IN-DELTA STORAGE PROGRAM DRAFT REPORT ON ENGINEERING INVESTIGATIONS

May 2002

Figure 13: Delta Wetlands Proposed Embankment Cross Sections

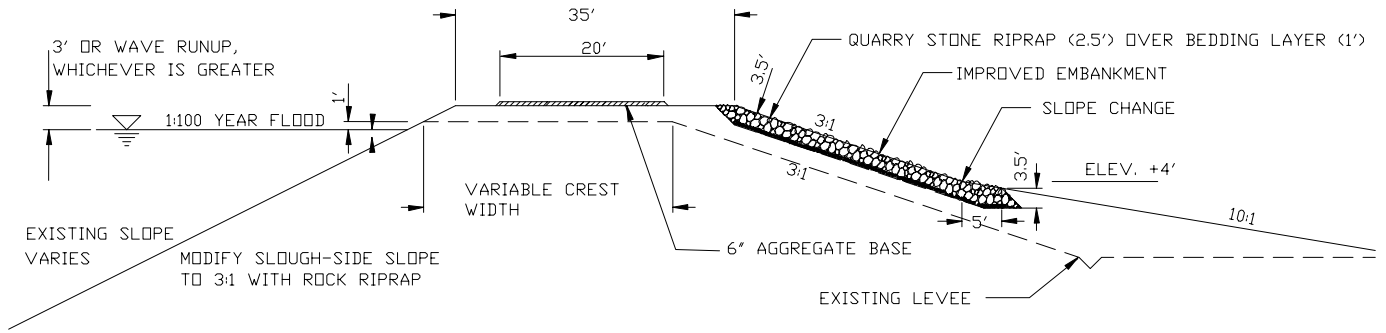
The new embankments proposed in the DW Project would not alter the existing river/slough-side slopes. Two configurations for the reservoir/island side slopes are proposed: a constant 5:1 slope, and a dual slope of 3:1 or steeper from the crest down to elevation +4, underlain by a slope descending at 10 to 1. Figure 13 in Appendix B illustrates these two proposed embankment configurations. The 2001 EIR/EIS indicates that more detailed studies would be done during final design to refine what slopes are needed in specific areas. These river/slough slopes are technically not acceptable as discussed in the static stability analysis sections.

The DW Project proposal indicates that modification will be done with one type of material placed directly on the existing structure. The material would come from natural sand deposits on the islands, and from dredge-spoil sites. As discussed in the settlement section, the embankments are subject to cracking from differential settlement and there is a potential for piping. To minimize the potential for a piping failure, the DW Project proposes to place sand against the inside of the existing levees. No specific information regarding the type of material, thickness, or basis for where it would be placed are provided.

Figure 14: Re-Engineered Embankment Cross-Section

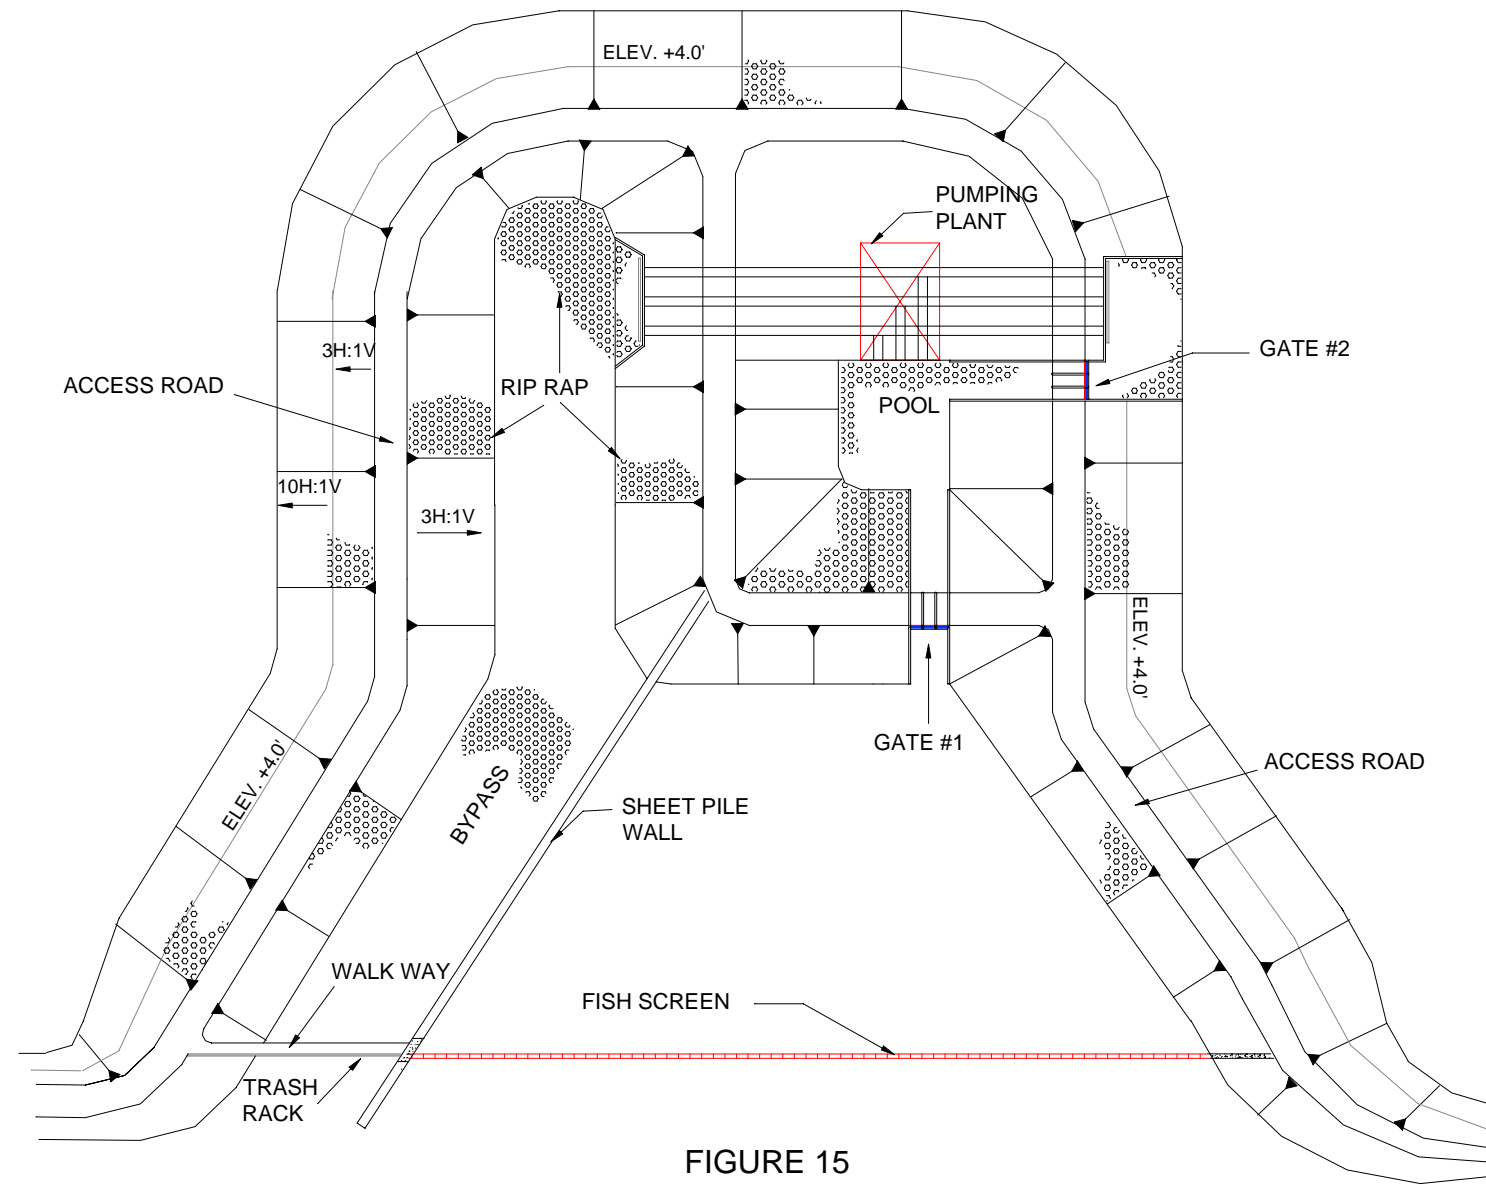
4. The existing river/slough side slopes in general do not meet the design criteria and in areas would be considered unacceptable. The DW Project did not recommend any modifications to these slopes and took the approach that a significantly wide enough crest would be used so that if sliding occurred the entire embankment would not fail and release reservoir water. This approach could cause environmental damage and safety issues, and result in costs that are not accounted for in the project.

Figure 14 in Appendix B illustrates the perimeter embankment configuration proposed by Reclamation/DWR.

5. For the re-engineered design, Reclamation/DWR assumed that the existing river/slough slopes would be to cut back to a 4:1 configuration above elevation 0 (MSL). This average configuration was used for computing quantities and cost at this level of design. As DFG has suggested modification of existing slough-side slopes to 3:1, cost of this modification was also estimated. More detailed studies should be done to determine specific areas of unstable slope and to determine what alternative designs could improve stability and reduce environmental impacts.
